# Mark III LOCA-Related Hydrodynamic Load Definition

Generic Technical Activity B-10  
Final Report

Office of Nuclear Reactor Regulation

Figure 3-1 Effect of Flow Cross-Section on Pool Swell Velocity in Distorted Geometry Tests. (Scale refers to the ratio of the cross-sectional areas to those in the full-scale system)

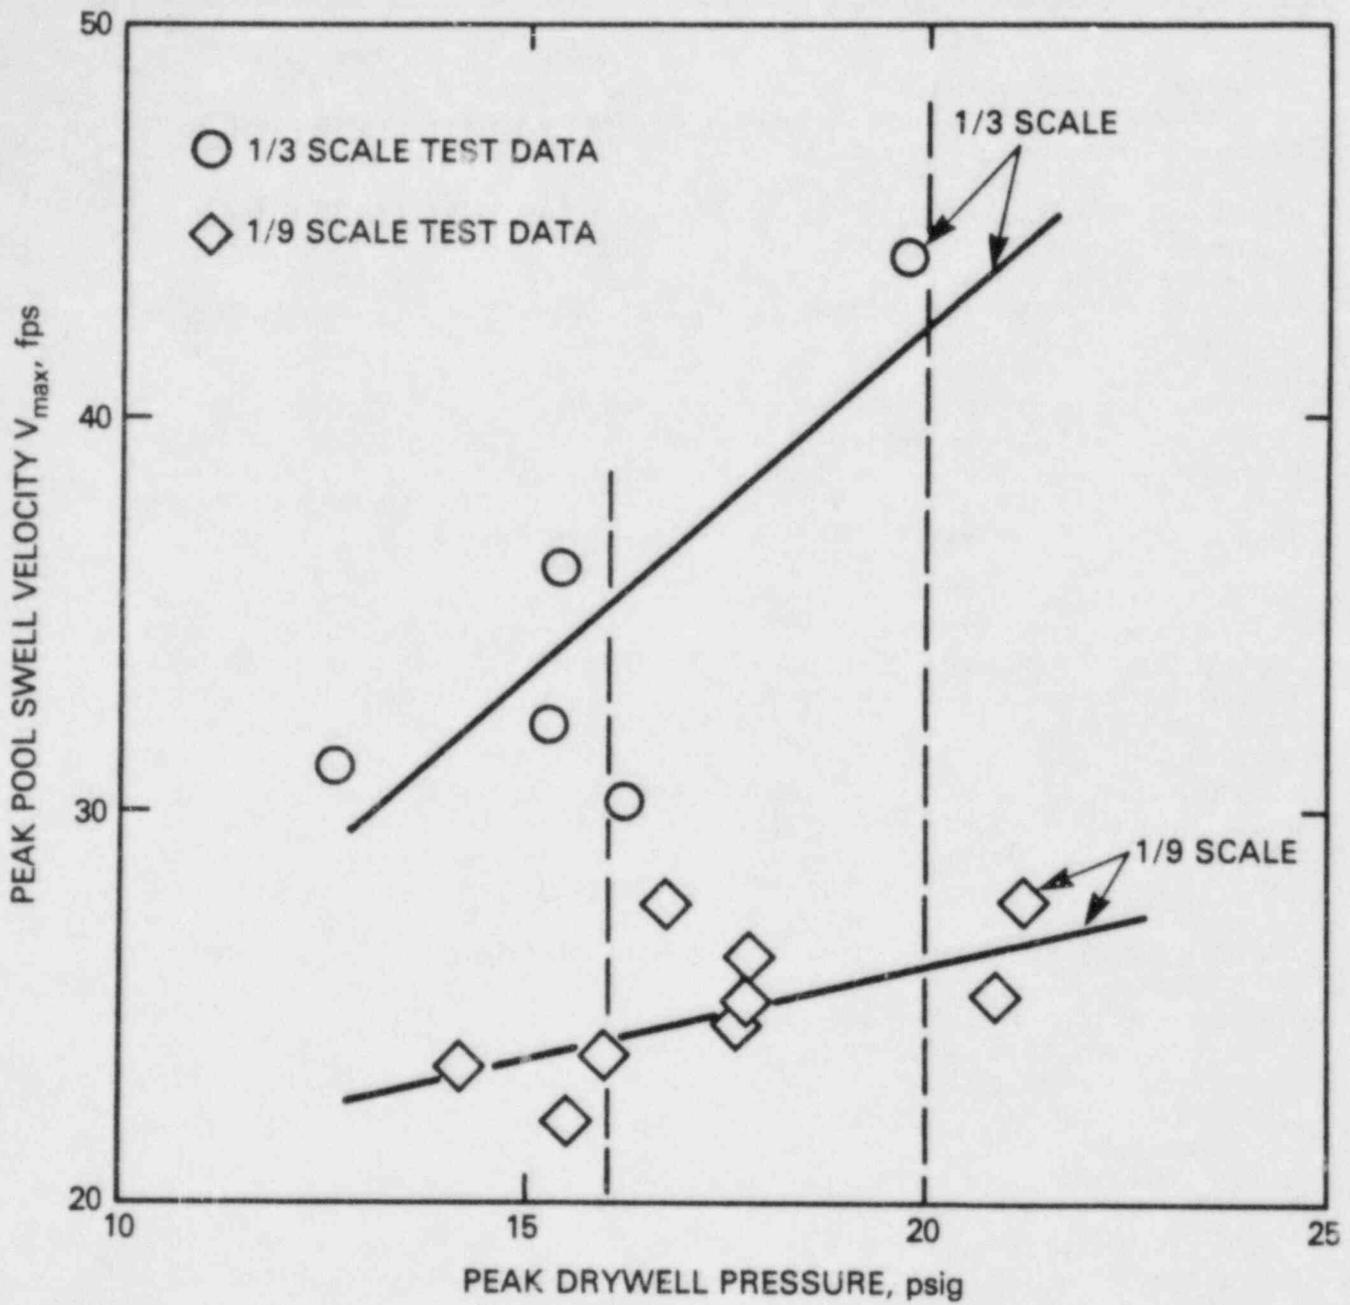
Figure 3-1 shows the peak swell velocities obtained in the 1/3 and 1/9 area-scaled systems as a function of peak drywell pressure. The data are for steam blowdowns, which the staff accepts as being representative of the DBA LOCA. At 20 psig, the 1/9 area-scaled system gives a velocity of about 25 ft/s, plus or minus about 2 ft/s; the 1/3 area-scaled system, on the other hand, gives a considerably higher velocity, about 42 ft/s (the corresponding figures quoted by GE are 26 and 33 ft/s, respectively; these are, however, based on an effective peak drywell pressure of 16 psig).

At a peak drywell gage pressure which is equivalent to 20 psig at full scale by linear scaling with system size, and a 5 ft submergence, the  $1/3$  area-scale system shows a peak pool swell velocity of 39 ft/s, which scales to 48 ft/s at full-scale conditions (Figure 3-2). GE's equivalent figure is 44 ft/s, because they take a 10% conservatism on the actual measured value.

Figure 3-3 Impact Force (per unit length) on Wedge-Shaped Protrusions from the Containment Wall

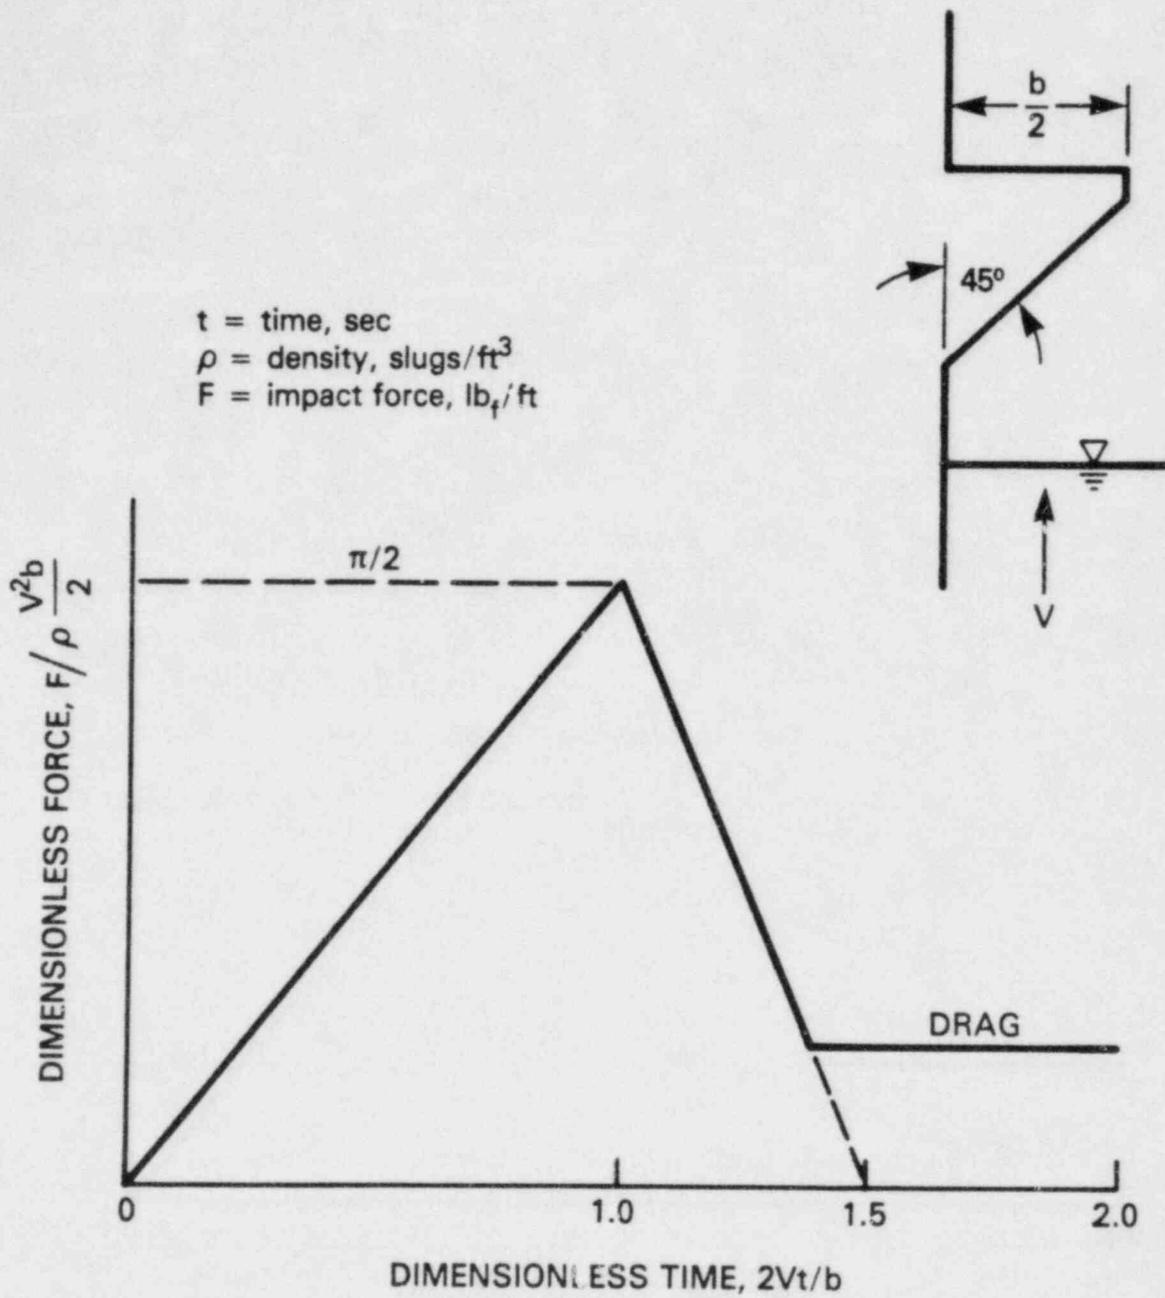
For half-wedge protrusions the force history during impact shall be determined from Figure 3-3. The local velocity of impact (needed in Figure 3-3) shall be taken from the specification in Section 3.2.1,

If the wedge angle is other than  $45^\circ$ , the following ratios can be used after obtaining the force history for a  $45^\circ$  wedge from Figure 3-3.

Figure 3-4 Impact Pressure on Horizontal Ledges Attached to Containment Wall

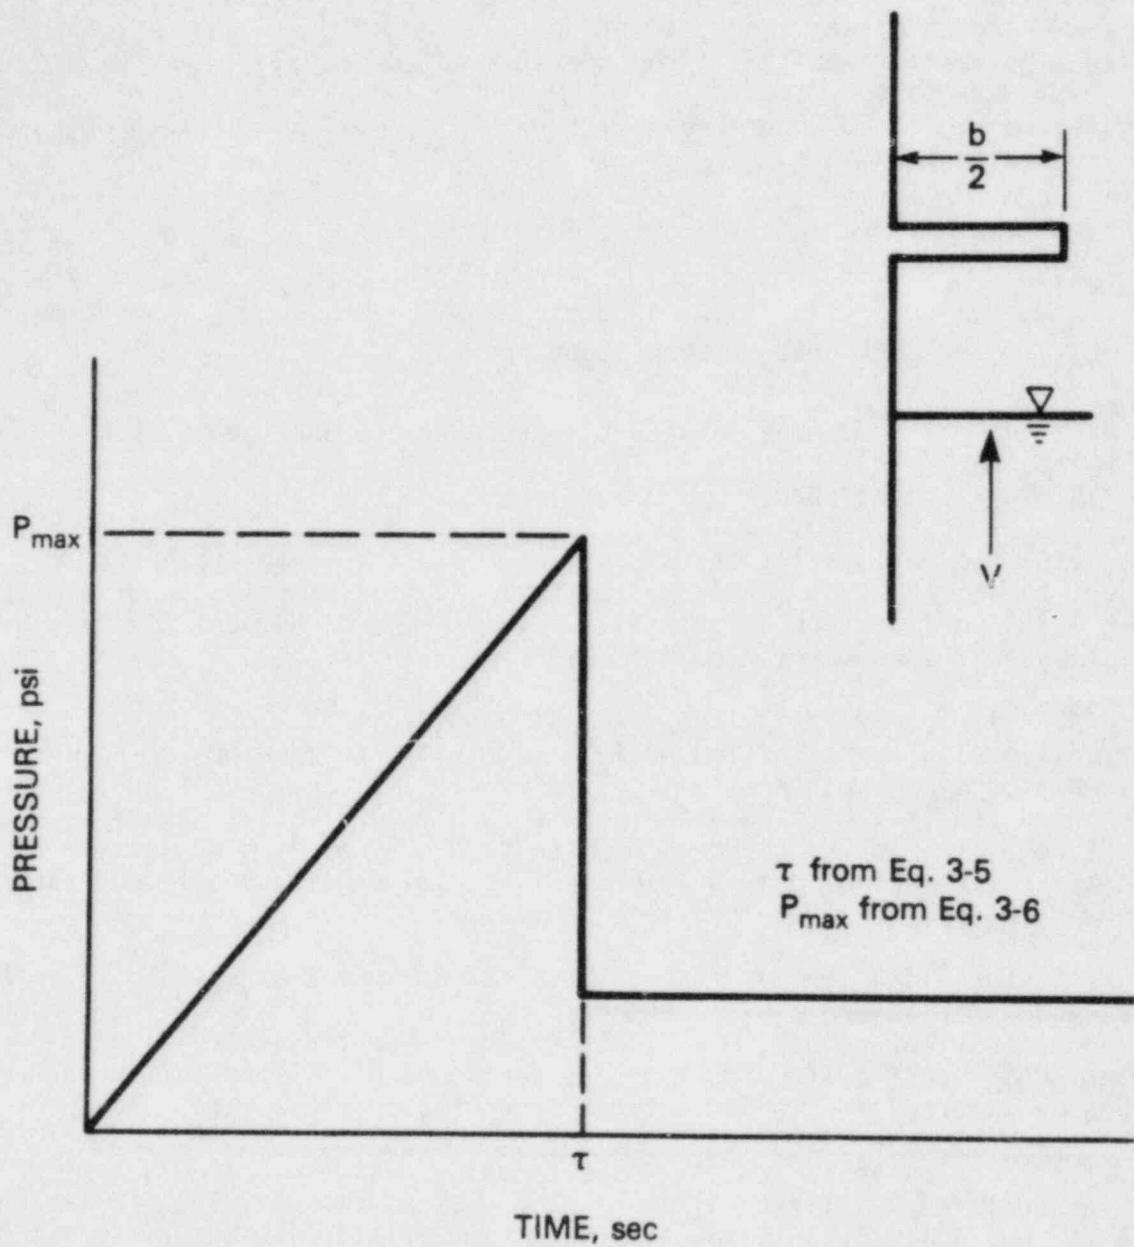
- (a) The force history will have a triangular shape as shown in Figure 3-4.
- (b) Determine the hydrodynamic mass of impact (per unit area) for flat targets from Figure 6-8 of NEDE-13426P.<sup>23</sup> Use  $b$  (and not  $b/2$ ) for target width.
- (c) Calculate the impulse using the equation

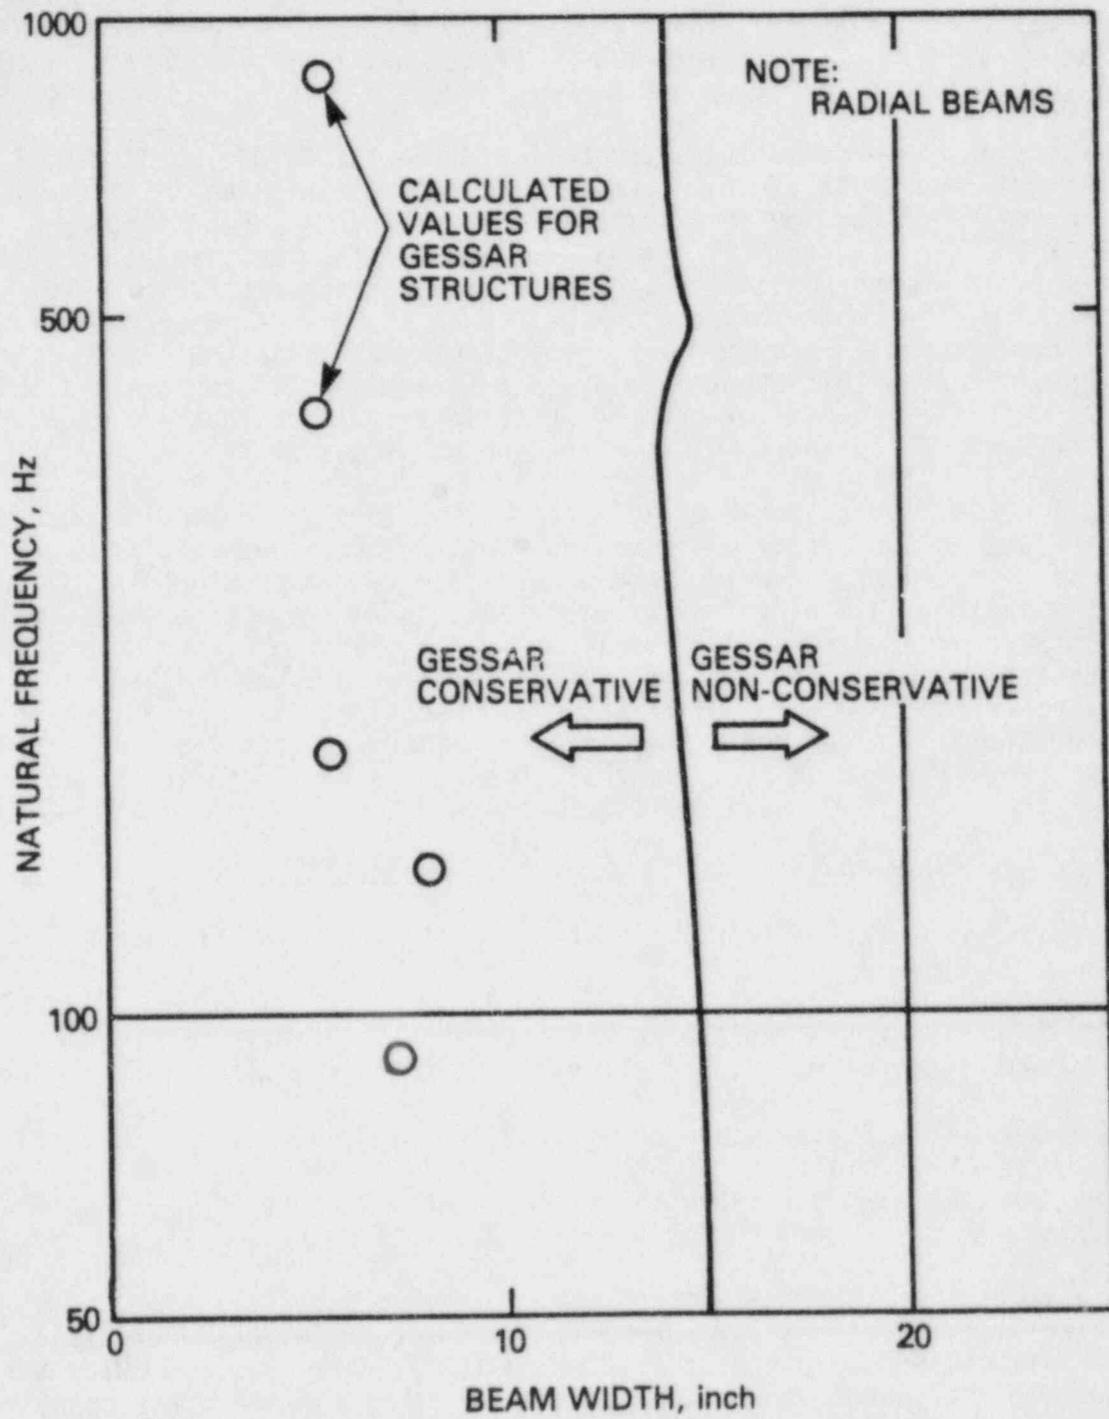
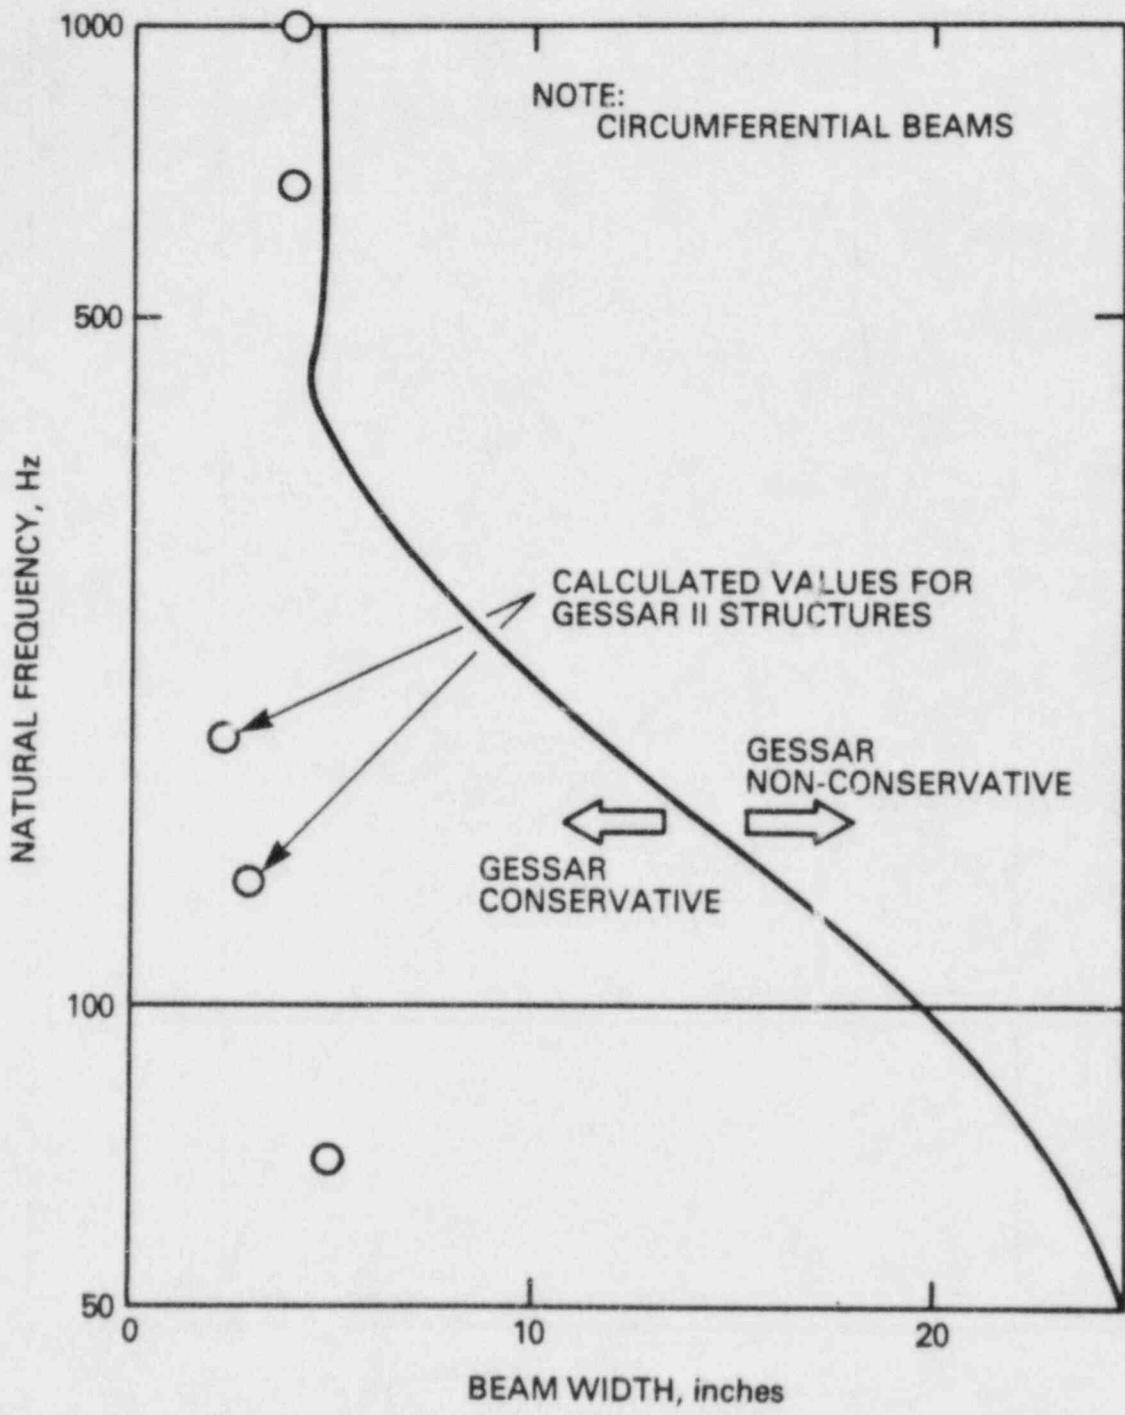
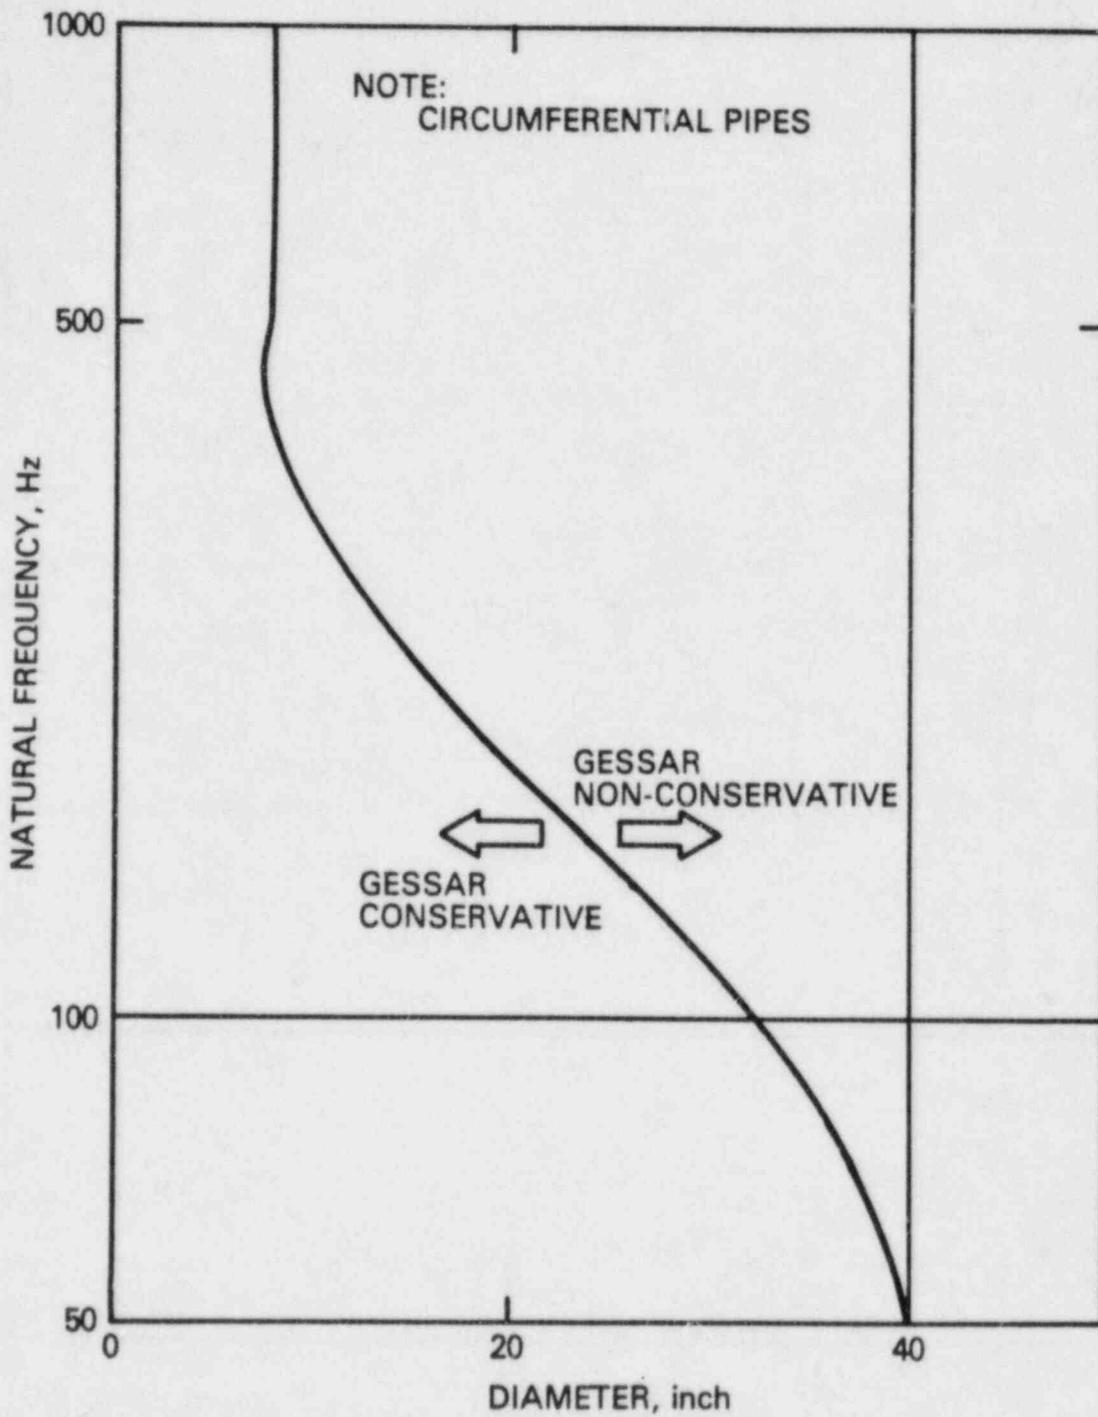
The results of these comparisons are best represented by plots of natural frequency vs. the width of the structure, as shown in Figures 3-5 through 3-7. These curves represent the locus of points where the two specifications, i.e., GESSAR-II and Mark II, result in equal stresses in the impacted structures. To the left of the curves, the GESSAR-II specification results in higher stresses, i.e., is conservative. The points on the graphs represent the specific structures located above the pool in the 238 Standard Plant. It is seen that, although this comparison has placed substantial constraints on the original GESSAR-II specification, the specific structures that are located above the Mark III pool are not overstressed above design.

The staff found this response acceptable, except for one particular concern. Since the pulse duration of 6.8 msec from Test Series 5805 was obtained with radial targets that spanned the pool annulus and were approximately 10 feet above the initial pool elevation, is this pulse duration appropriate (small enough) for shorter targets and for lower target elevations where the pool would be less curved? In response to this concern, GE demonstrated in Response 33 (Section 3B0.3.2.33 of GESSAR-II) that, for the specific targets above the Standard Plant pool, i.e., shortest target 4 feet long and closest distance above the pool of 6 feet, the 6.8 msec was still conservatively short.

- (1) The impacted structures are in the "conservative" areas on plots of natural frequency vs. size. (Figures 3-5 through 3-7).
- (2) The impacted structures are at least 4 feet in length.
- (3) The impacted structures are not closer than 6 feet to the initial pool surface.
